TRANS/WP.29/2003/11
12 December 2002

World Forum for Harmonization of Vehicle Regulations (WP.29)
(One-hundred-and-twenty-ninth session,
11-14 March 2003, agenda item 4.2.11.)

PROPOSAL FOR DRAFT SUPPLEMENT 3 TO REGULATION No. 98

(Headlamps with gas-discharge light sources)

"Annex 4 - Appendix 1

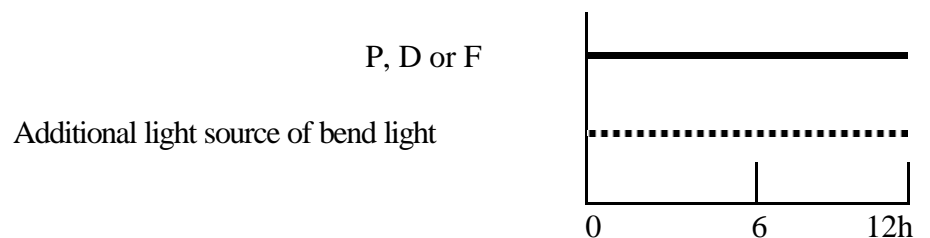
Annex 4, paragraph 1.1.1.1., add a new subparagraph (d) to read:

"(d) In the case of a passing beam designed to provide bend lighting with the addition of a light source, this light source shall be switched on for 1 minute, and switched off for 9 minutes during the activation of the passing beam only (see annex 4 - appendix 1)."

Insert new Annex 4 - appendix 1, to read:
